# MIAMI BEACH

### Design Review Board

SUBJECT: DRB17-0202  
**6300 North Bay Road – Single Family Home**

The applicant, NBR7 LLLC, is requesting Design Review Approval for the construction of a new two-story single family residence to replace an existing two-story architecturally significant pre-1942 single family residence, including a variance to exceed the maximum lot coverage allowed.

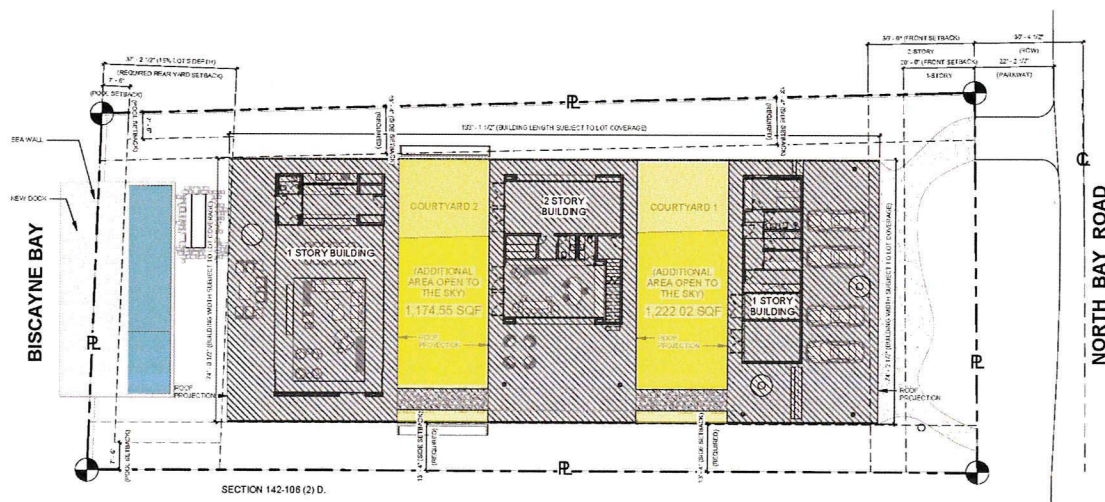
The proposed two-story, single family residence is unconventionally distributed on the site as three, separate structures that are evenly arrayed within the developable envelope of the site. The proposed design creates two expansive outdoor recreational courtyards between the main massings of the residence. The design envisions indoor-outdoor living to the extreme. The yard areas are predominantly open to the sky and provide ample private recreational areas for the residents. A variety of outdoor spaces are dispersed throughout the property. For purposes of calculating lot coverage, internal courtyards that are open to the sky yet, but which are substantially enclosed by the structure on three or more sides, must be included towards the lot coverage calculation. The areas highlighted below illustrate about 3,480SF of outdoor unroofed area that has been included in the excessive lot coverage calculation of 53%.

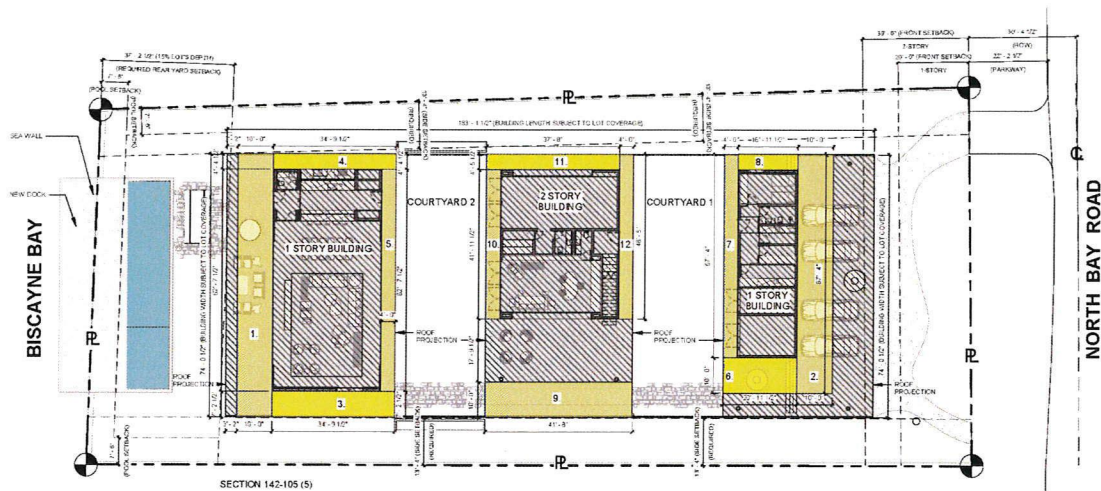
Further analysis of the lot coverage calculation also takes into account outdoor covered areas that are open on at least two sides. The Code exempts those covered areas that area attached to main building and project 10 feet or less from being included in the overall lot coverage calculations The areas highlighted below illustrate the nearly 3,520 SF of covered open areas that, in addition to uncovered outdoor area, constitute the excessive lot coverage of 53%.

If the total outdoor area of nearly 7,000 SF were to be subtracted out of the lot coverage for anyalsis purposes, the design proposal would be requesting a lot coverage of 25.7%--nearly 5% below the zoning allowance for two-story structures.
